# Environmental Minor Project Refinement Form

Project Name: West of Devers Upgrade Project Request Prepared By: Sylvia Granados

Date Approval Required: 5/29/2018 Variance Request No.: 14

Specify Source (e.g., Mitigation Measure B.5): Modification to NTP #3 Subtransmission Work Area Mapping.

FIGURE 1

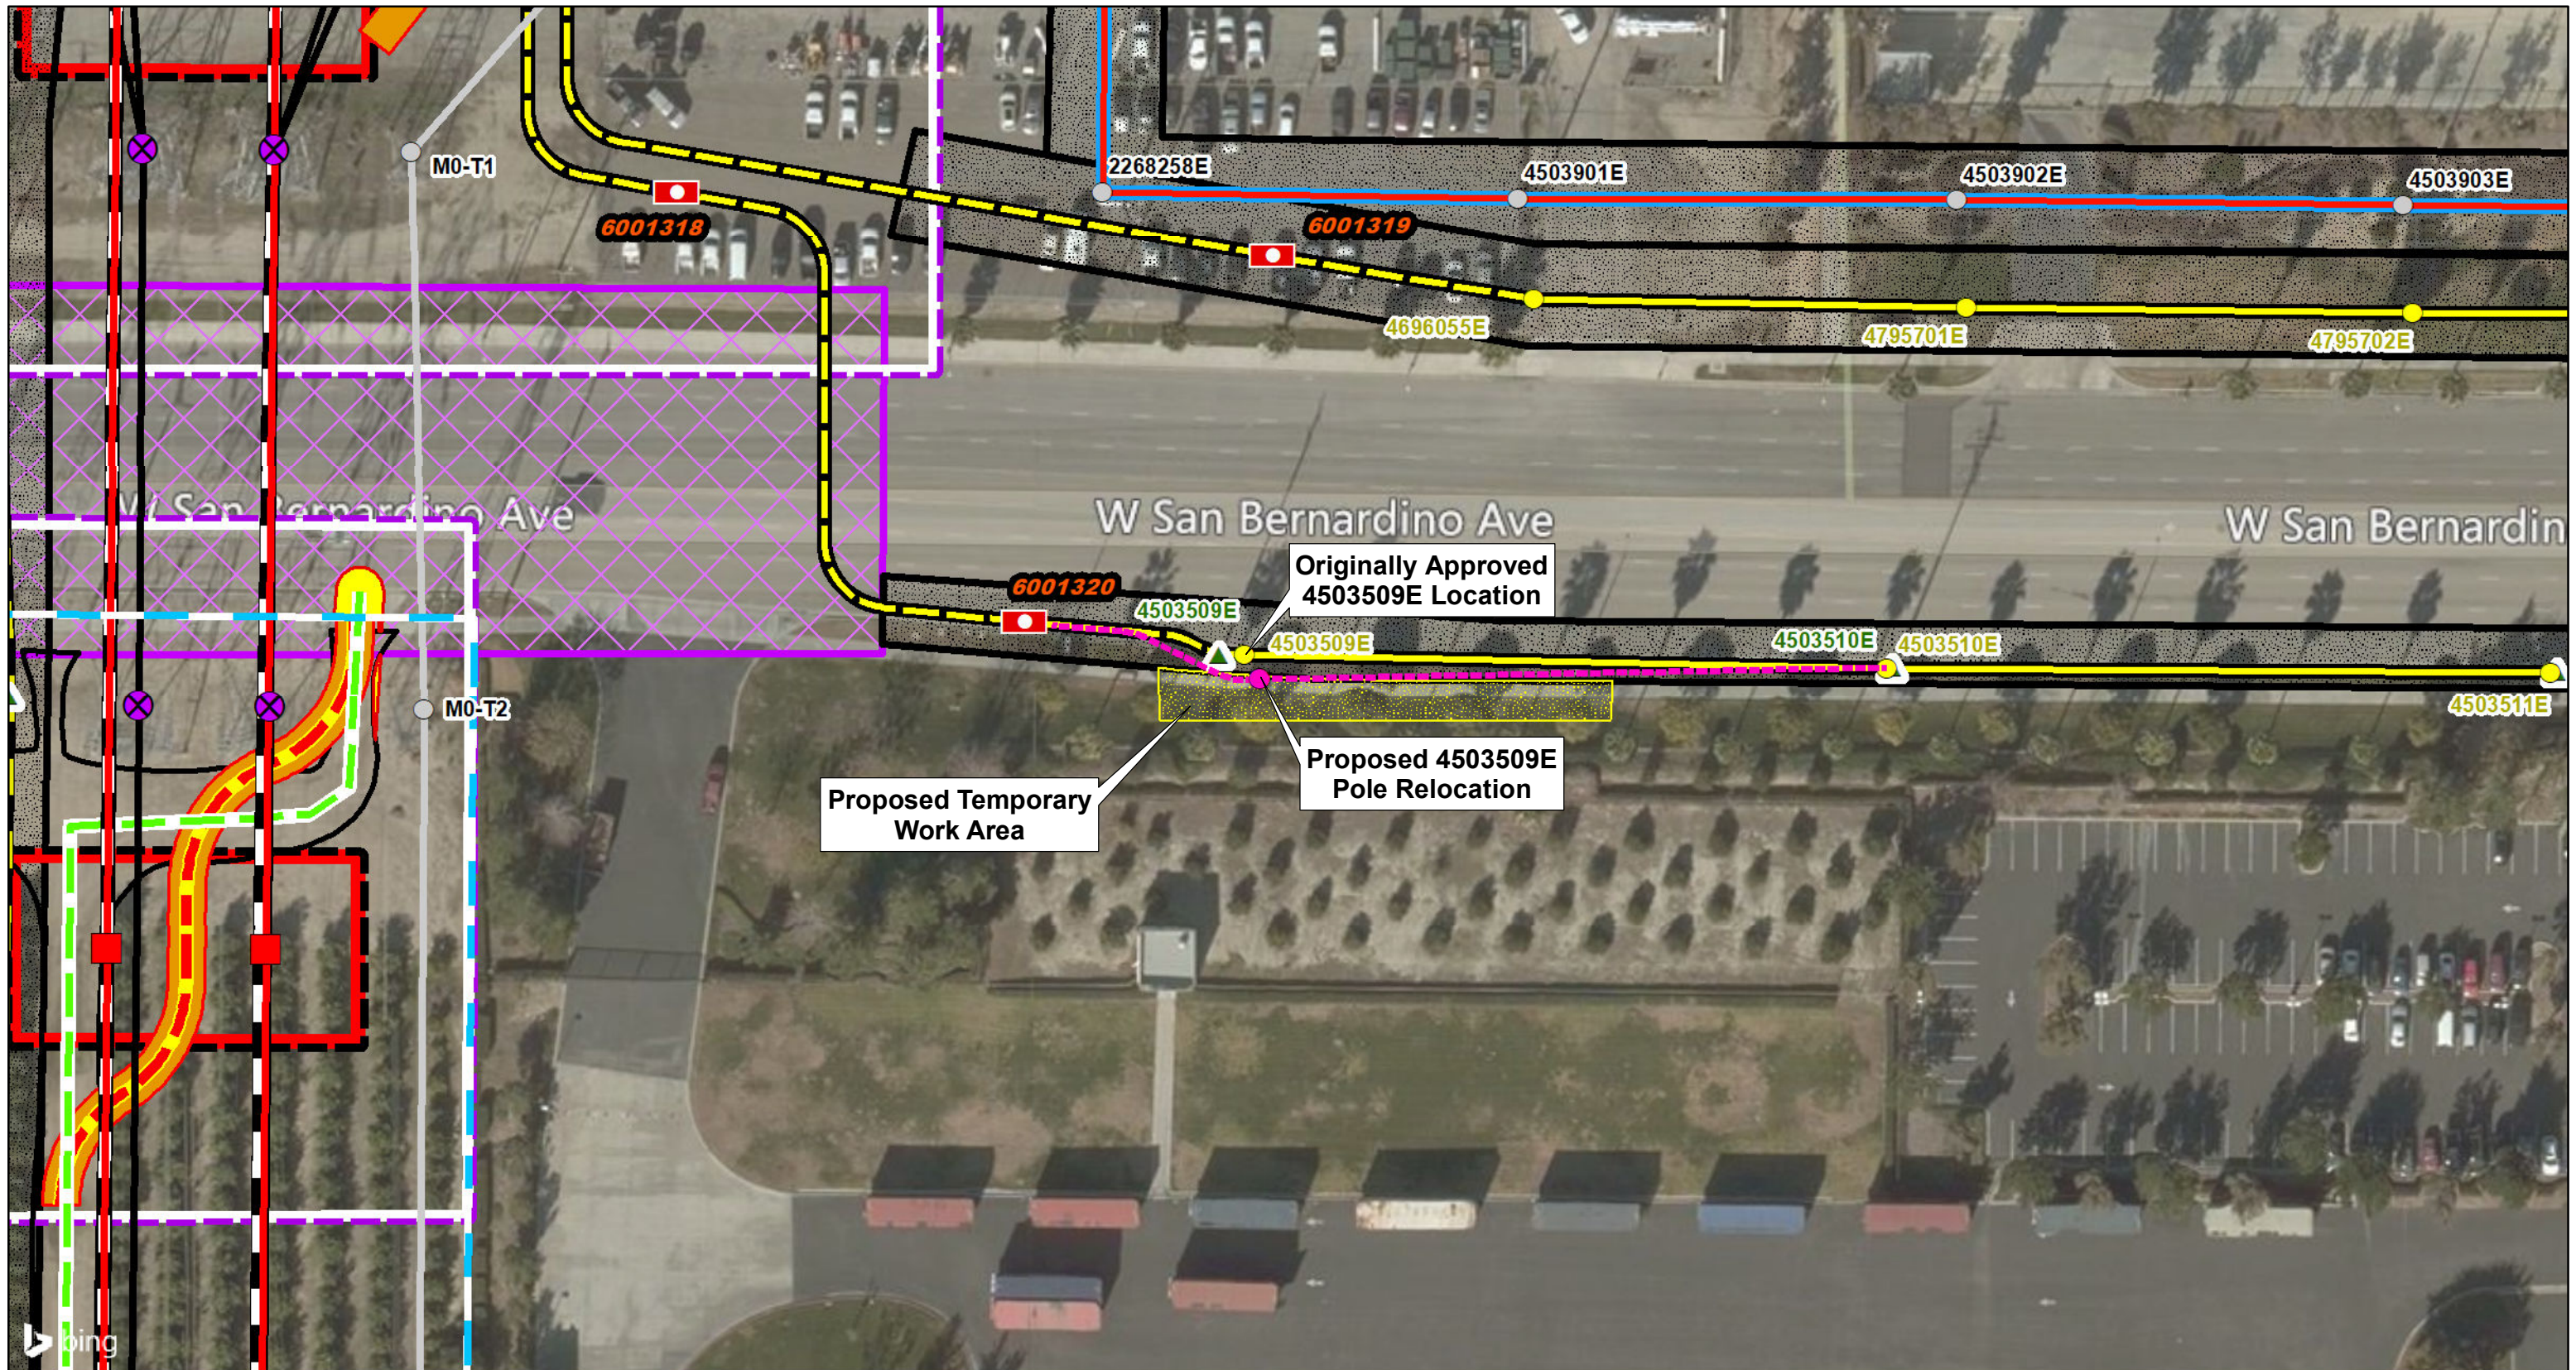
### **TSP 4503509E installation in front of 2821 W. San Bernardino Avenue, in the City of Redlands**

Due to underground utility conflicts encountered in the approved work area, the location of TSP 4503509E, along the San Bernardino–Redlands–Timoteo 66-kV subtransmission line, requires adjustment to the south, as shown in Figure 1.

The temporary impacts to developed/disturbed land associated with the redesign are 0.06 acre.

OWNER IS IN CONDEMNATION, . CAN ONLY  
WORK IN FRANCHISE AREA, WHICH IS  
60 FEET FROM CENTERLINE OF SAN  
BERNARDINO AVE.

FIGURE 2

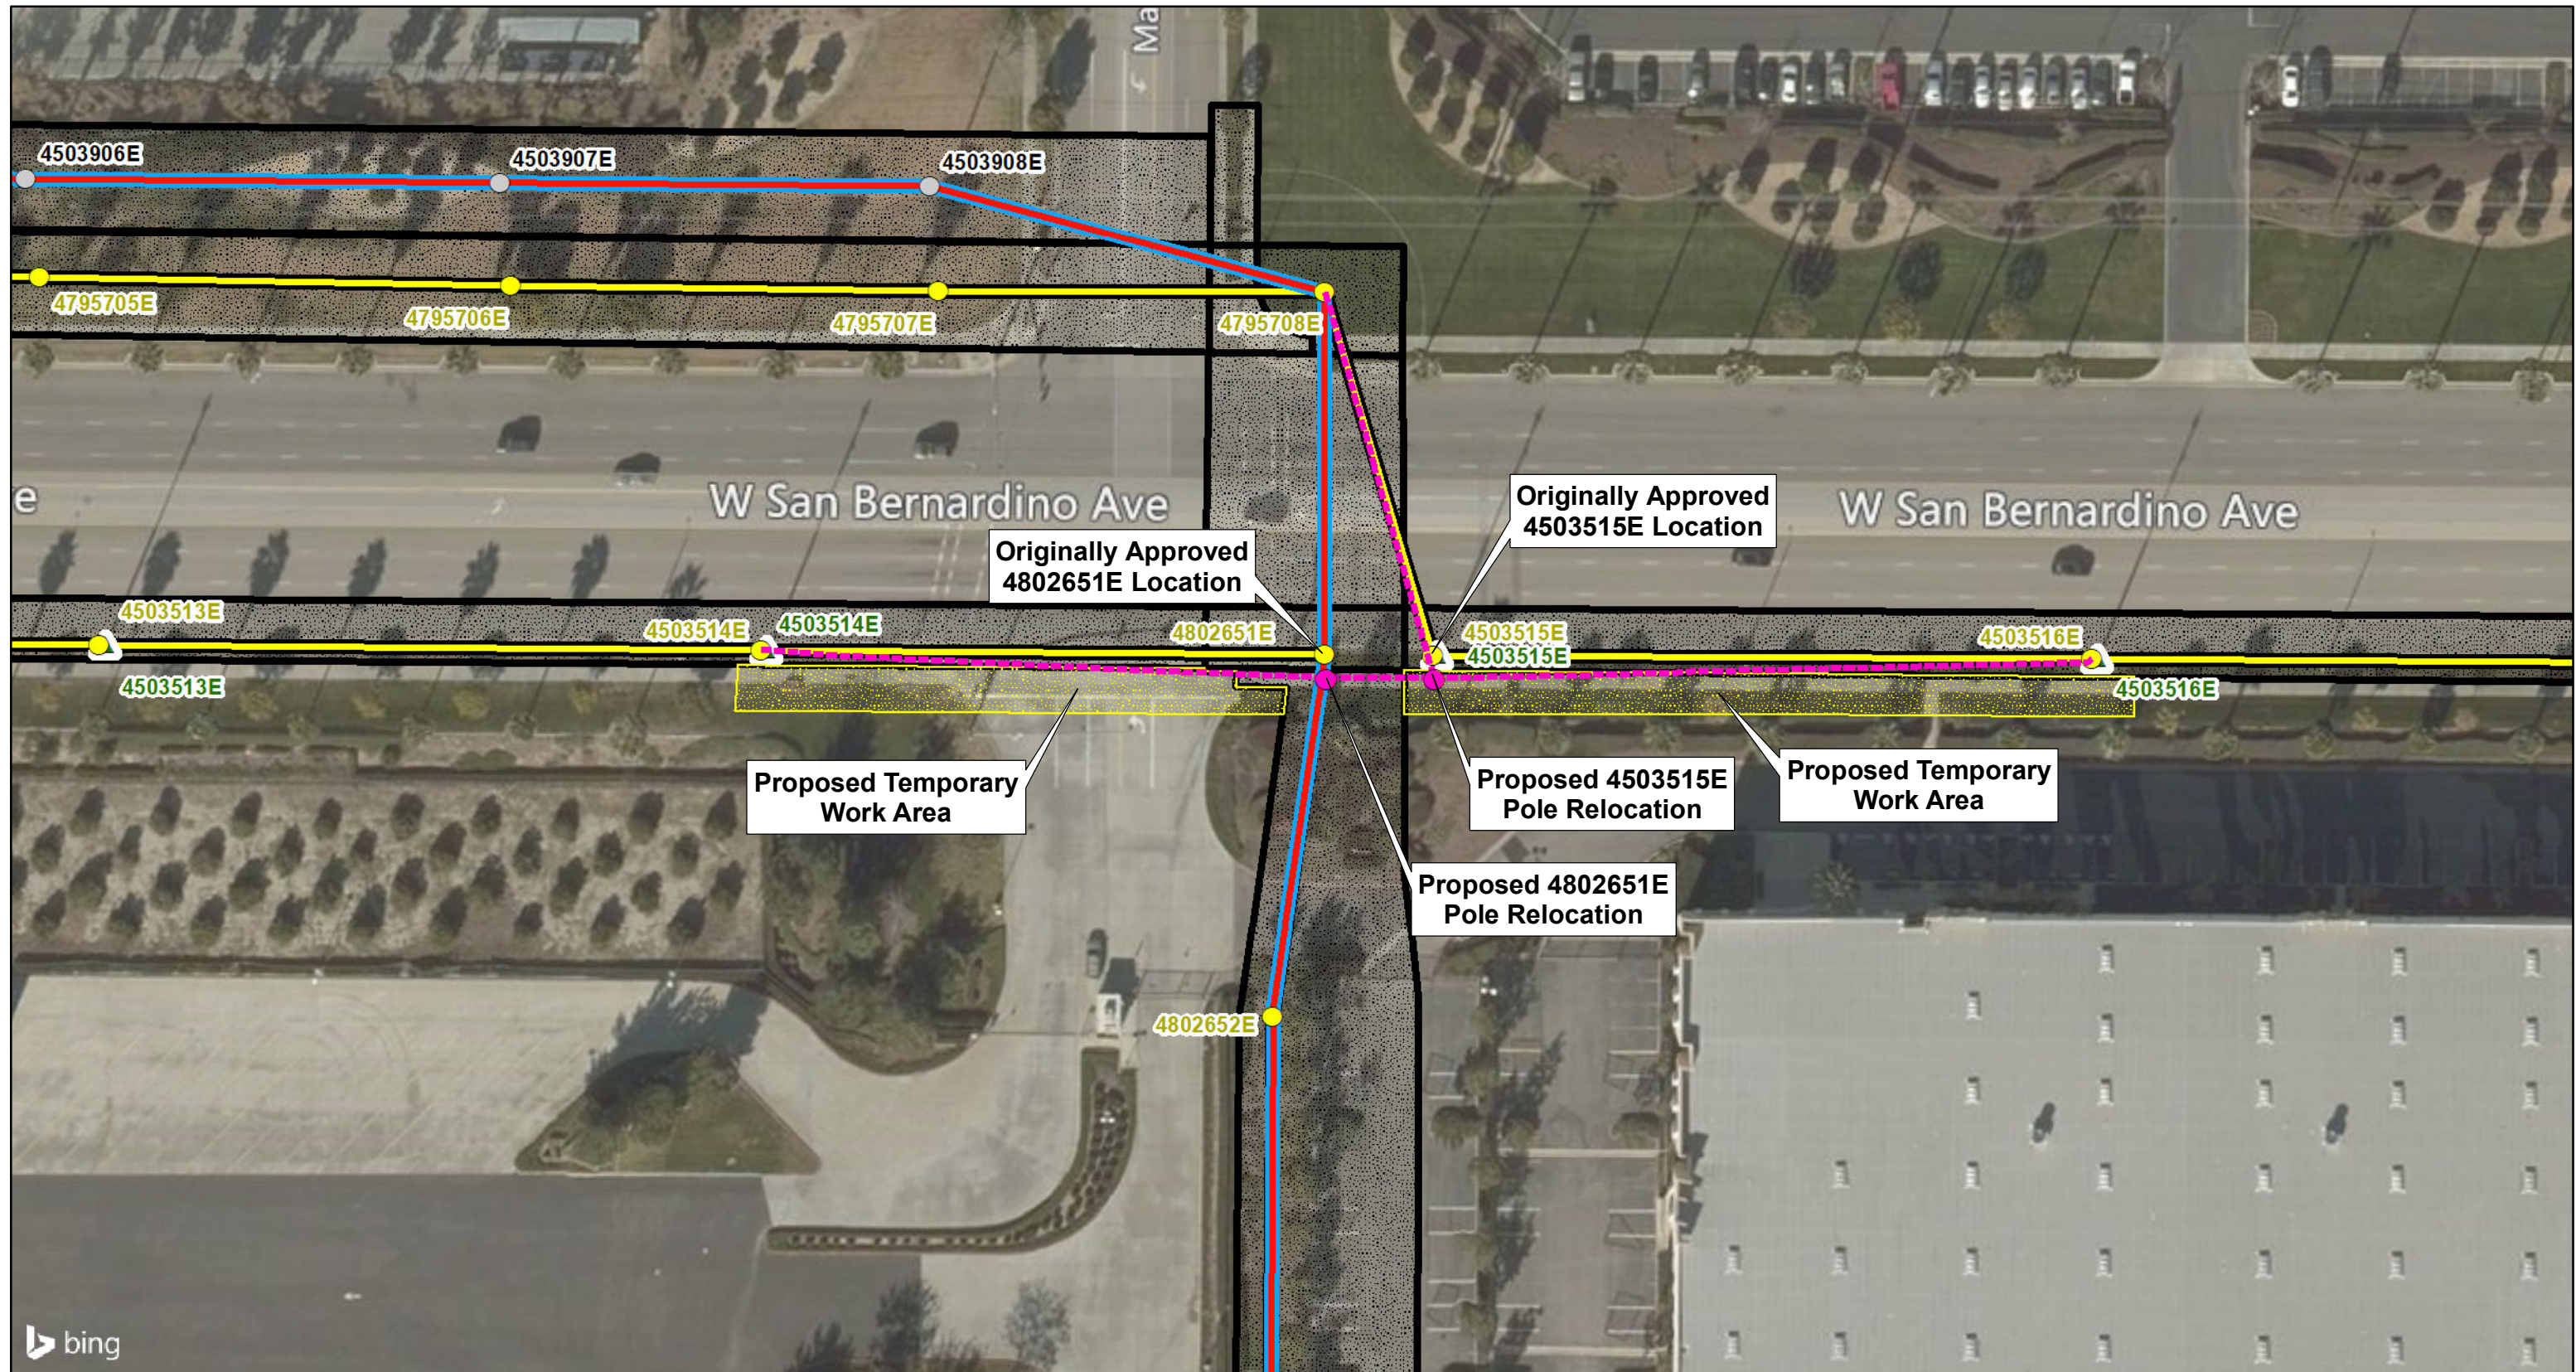
### **TSP 4802651E and TSP 4503515E installations on the southeast corner of Marigold Avenue and W. San Bernardino Avenue, in the City of Redlands**

Due to underground utility conflicts encountered in the approved work area, the locations of TSP 4802651E, along the San Bernardino–Redlands–Timoteo 66-kV subtransmission line, and TSP 4503515E, along the San Bernardino–Redlands–Tennessee 66-kV subtransmission line, require adjustment to the south, as shown in Figure 2.

The temporary impacts to developed/disturbed land associated with the redesign are 0.18 acre.

FIGURE 3

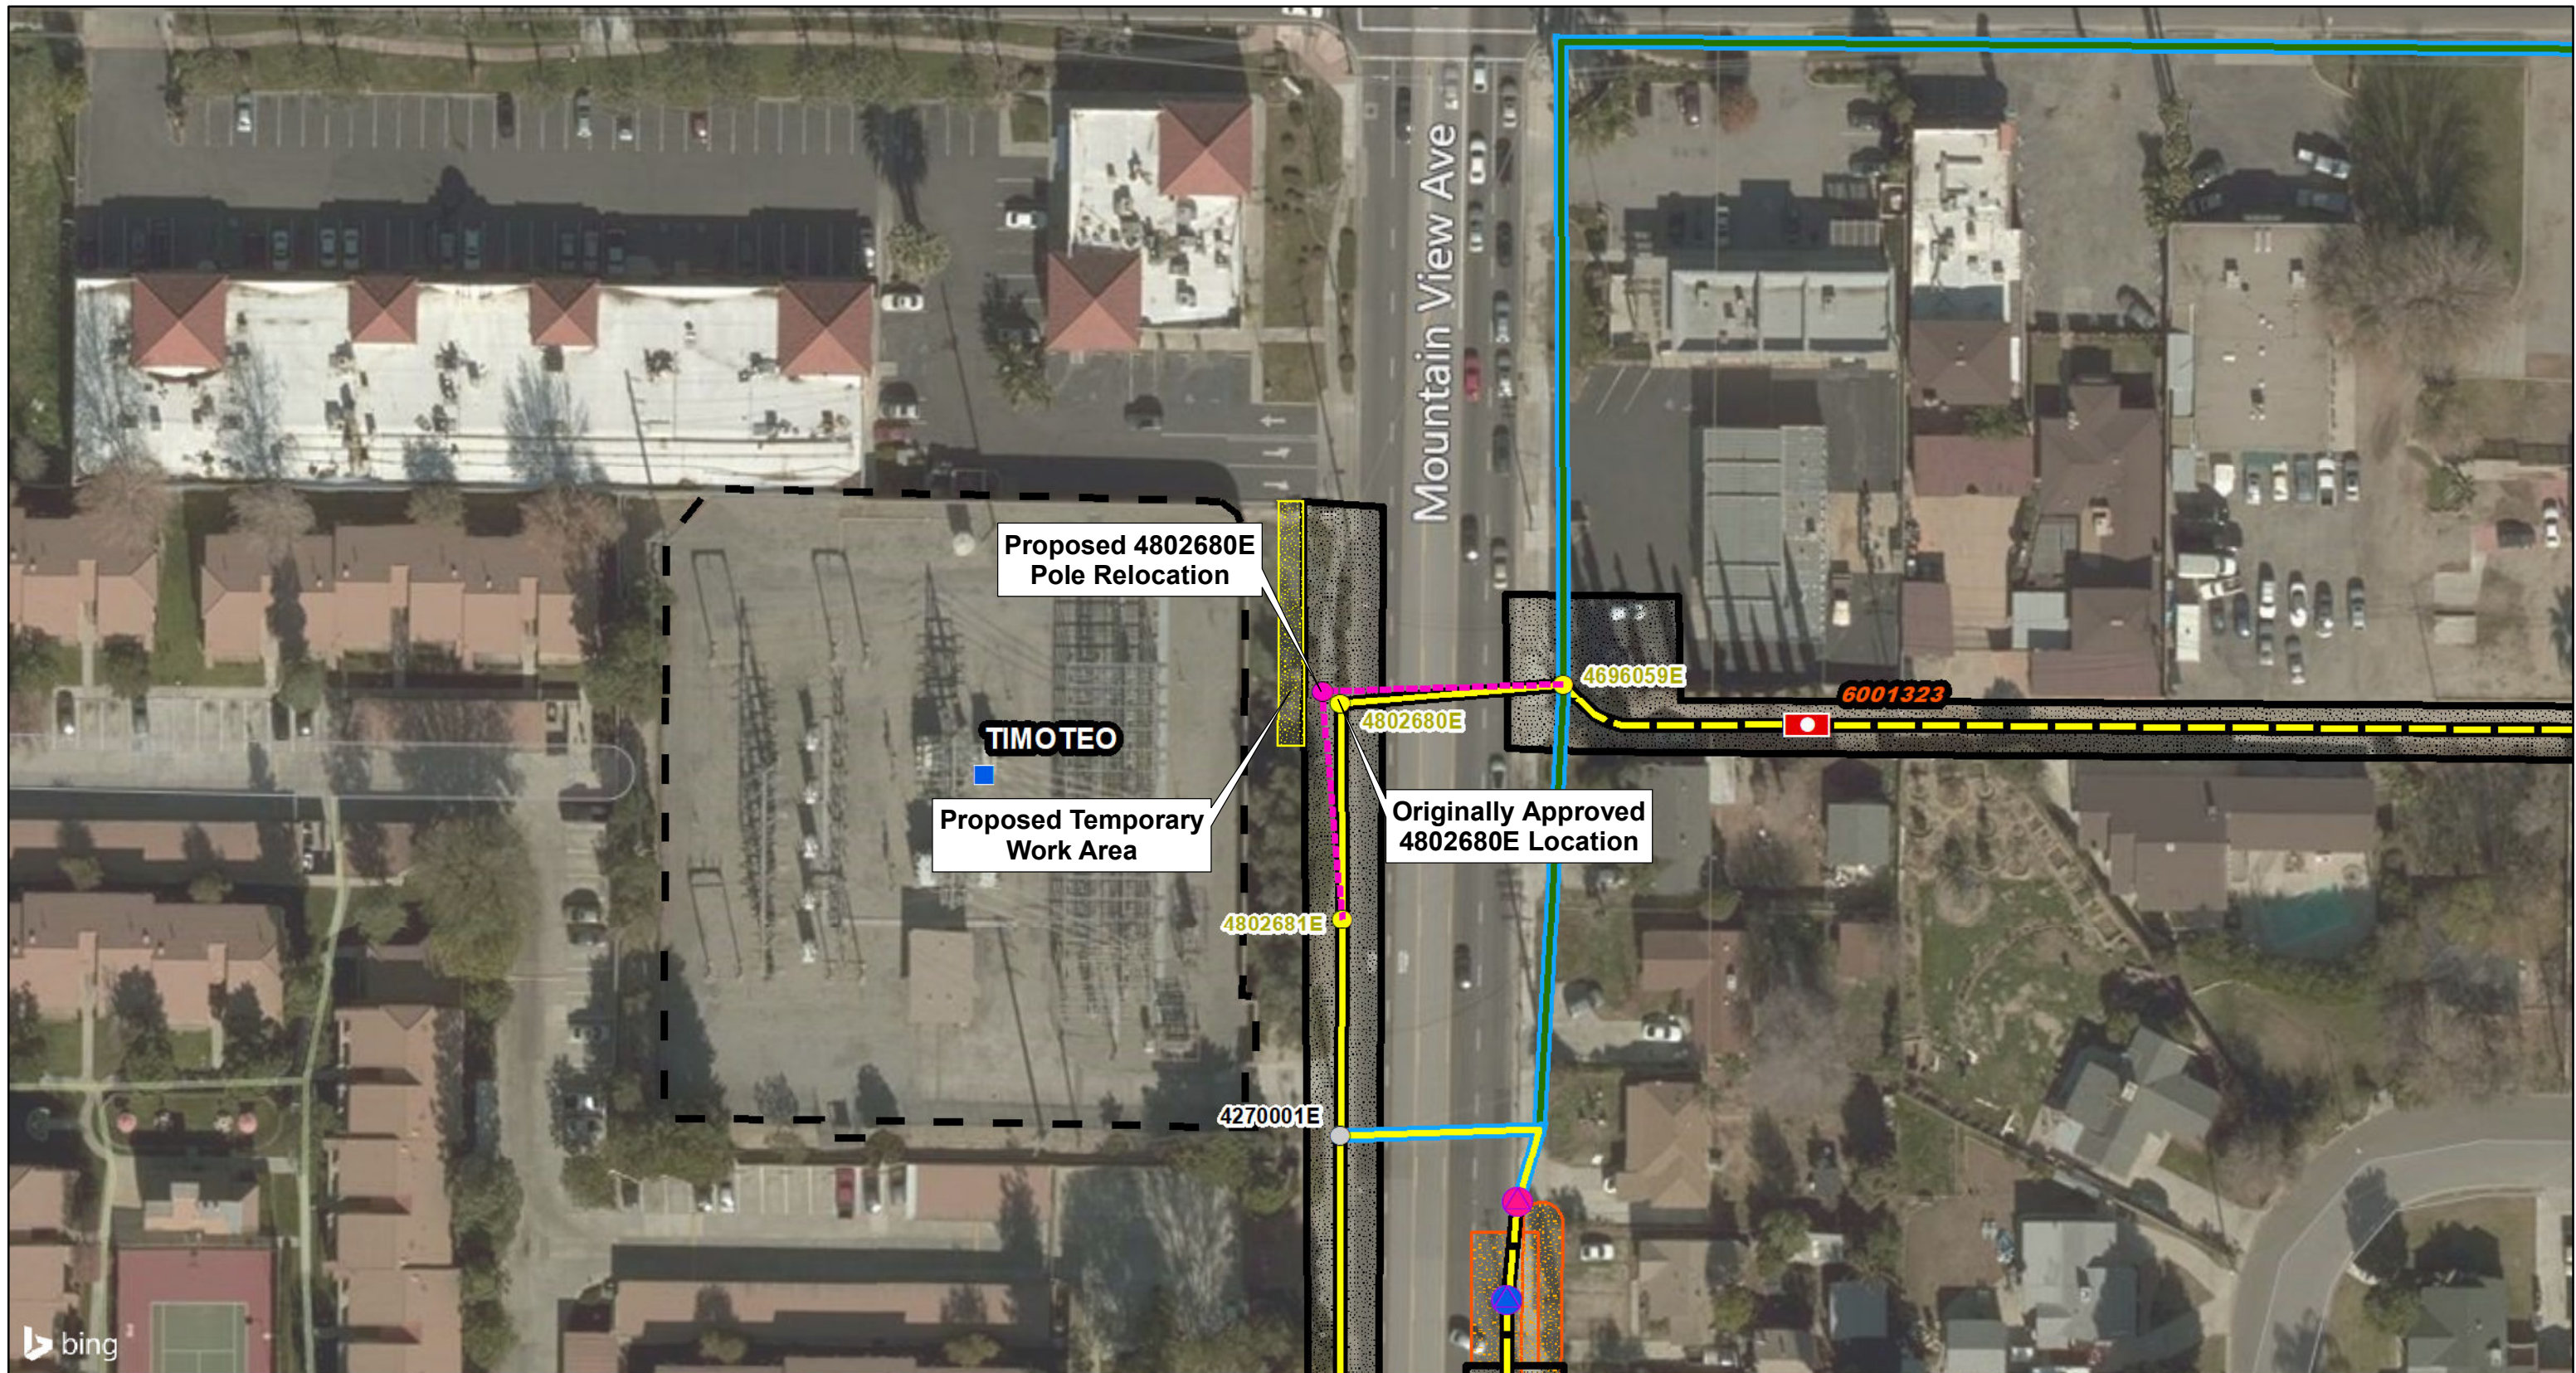
### **TSP 4802680E installation in front of the Timoteo Substation, in the City of Loma Linda**

Due to underground utility conflicts encountered in the approved work area, the location of TSP 4802680E on Mountain View Avenue, along the San Bernardino–Redlands–Timoteo 66-kV subtransmission line, requires adjustment to the west, as shown in Figure 3.

The temporary impacts to developed/disturbed land associated with the redesign are 0.02 acre.
